# UNITED STATES PATENT AND TRADEMARK OFFICE

| APPLICATION NO.   | FILING DATE | FIRST NAMED INVENTOR | ATTORNEY DOCKET NO. | CONFIRMATION NO. |
|---|-------------|----------------------|---------------------|------------------|
| 10/506,991  | 09/09/2004  | Shigeho Inatsune     | 257416US2PCT        | 1935             |

| <b>Office Action Summary</b> | <b>Application No.</b><br>10/506,991 | <b>Applicant(s)</b><br>INATSUNE, SHIGEHO |  |

**FIG. 4**  
**PRIOR ART**

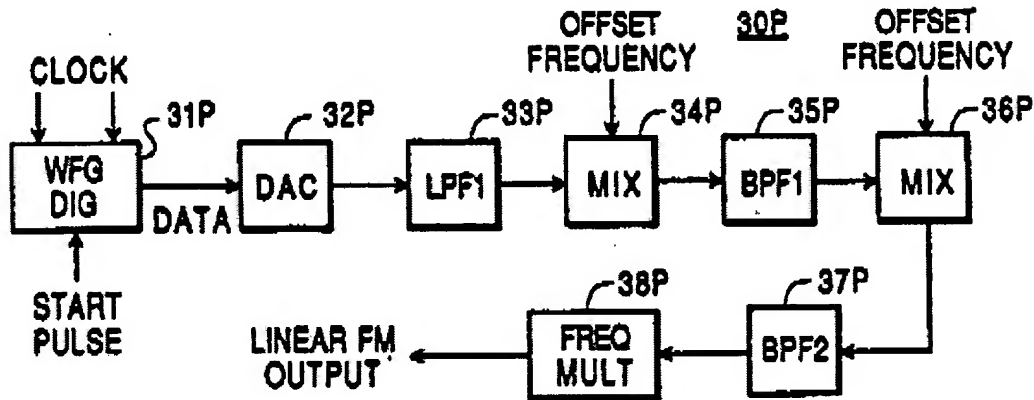
Caldwell et al ('661) disclose, referring to FIG. 4 reproduced below,

a clock timing section with start pulse, D/A converter 32P, and low pass filter 33P.
